# Product Advisory

<b>Product Family:</b>	ZIPLink Servo cable for CN1 connector	<b>Number:</b>	PA-ZL-008
<b>Part Numbers:</b>	See Products Affected below	<b>Date Issued:</b>	11/01/17
<b>Subject:</b>	Loose connection on Servo cable when attached to break out board	<b>Revision:</b>	2nd Ed.

**ZL-SVC-CBL50, ZL-SVC-CBL50-1, ZL-SVC-CBL50-2, ZL-CBL50-1P, ZL-CBL50-2P, ZL-RTB50, SVA-2040, SVA-2100, SVA-2300**

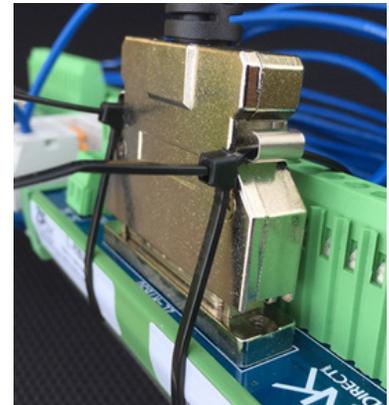
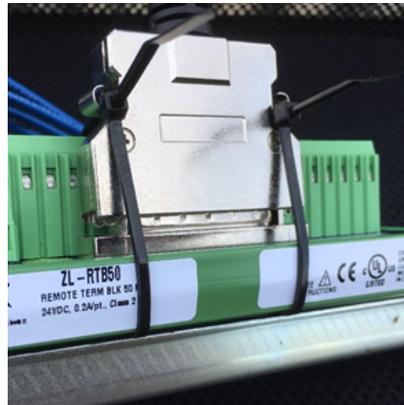
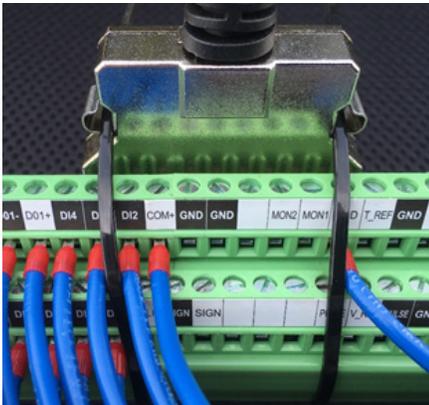
AutomationDirect has discovered a connection issue that occurs with some of the ZL-SVC-CBL50 series cables when connected to the ZL-RTB50 feedthrough module.

We found on some of the cables that the mating connection of the two parts can loosen over time, or from vibration. In some rare instances the loss of signal connection can be seen immediately.

Affected cables are ZL-CBL50-1P, ZL-CBL50-2P, ZL-SVC-CBL50, ZL-SVC-CBL50-1, and ZL-CBL50-2P with silver metal housings.

Older cables with a beige plastic housing are not affected.

If the manufacturer's solution below is something you do not feel is feasible for you to implement, we recommend that you secure the cable to the feedthrough module using two zip ties. See the examples below. If your cable already has attaching spring clamp connection then you must perform the Manufacturer's Solution below.

Starting with units manufactured after **November 2016**, the manufacturer has re-designed the module and the cables to include a screw down connection for the connector housing. This allows you to make a secure connection and eliminates this problem.

### Step 2:

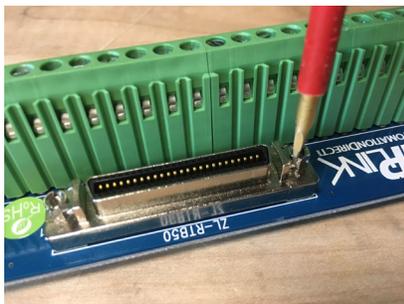
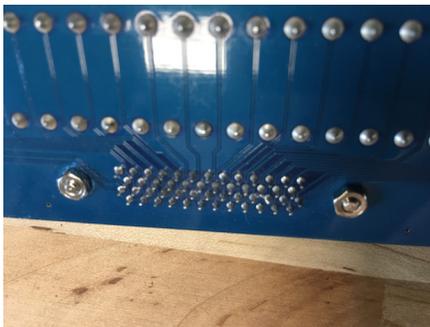
Disassemble the housing as shown to access the two screws on the back of the printed circuit board and remove the screws.

You can now install the two supplied standoff screws. Be sure to install the nuts on the backside of the printed circuit board so the connector assembly is secured to the circuit board. The use of a thread locker adhesive can be used to reduce the chance of loosening.
